Executive Director's Recommendation

PROJECT
Consolidated Planned Unit Development and Related Map Amendment at Square 744S and 744SS (DC Water)
O Street Pumping Station
Bound by N Pl. SE, Canal St. SE, private property, and the Anacostia River

NCPC FILE NUMBER
ZC 15-14

APPLICANT'S REQUEST
Approval of report to the Zoning Commission of the District of Columbia

1 SECTION - PENTHOUSE ENCLOSURE (1)

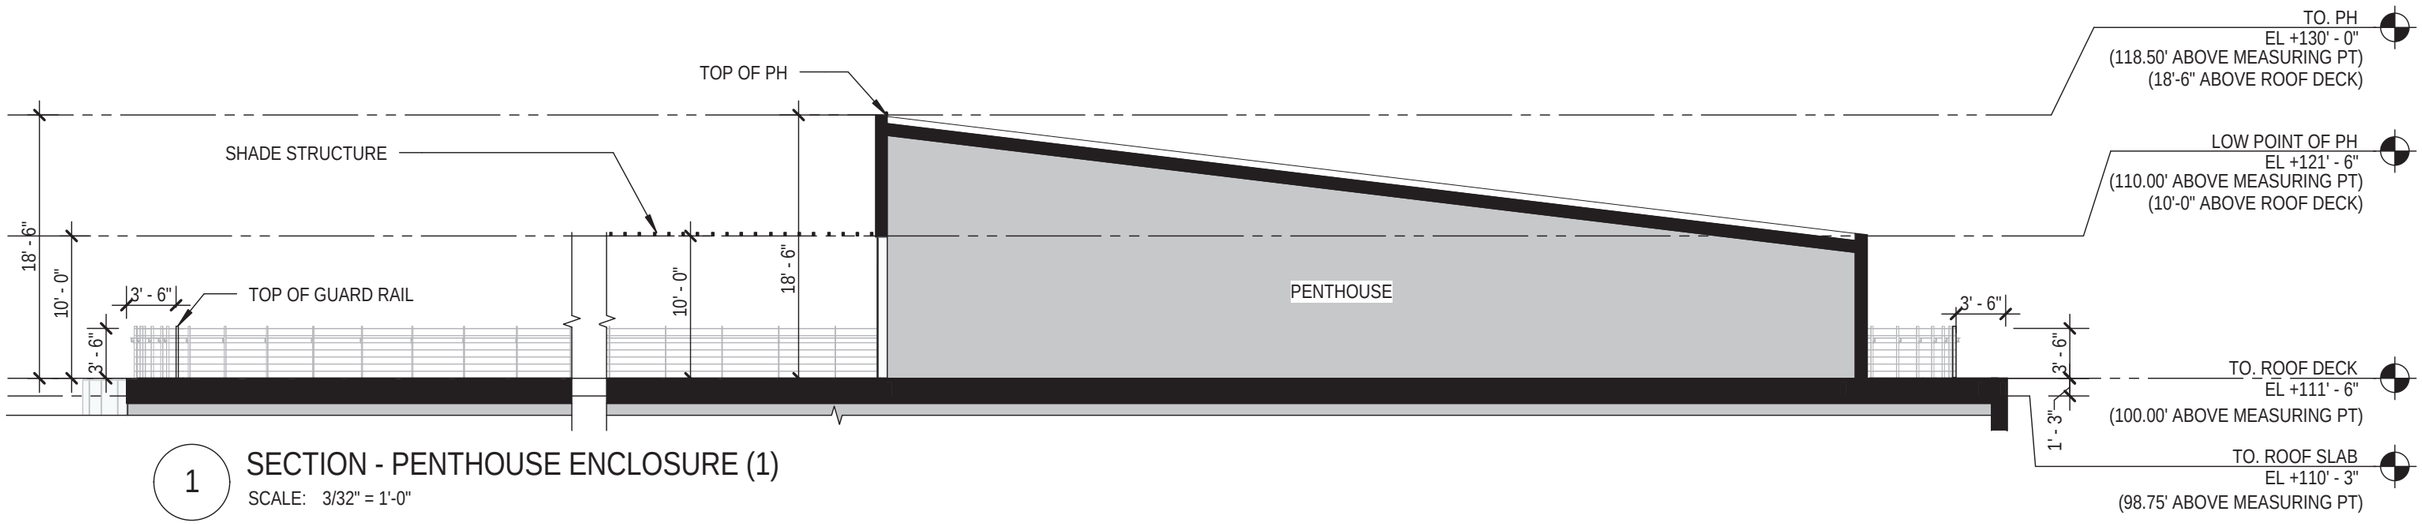
- The Consolidated PUD's proposed height of 100 feet is at the allowable height under the Height of Buildings Act (Height Act) feet based on the 80-foot right-of-way width of Canal Street SE. On December 21, 2015, the applicant provided revised drawings to the Zoning Commission that eliminated a proposed parapet that exceeded the allowable height under the Height Act; the revision now includes a continuous 3'6"-high guardrail that is set back from the roof edge at a 1:1 ratio, which conforms to Height Act requirements.
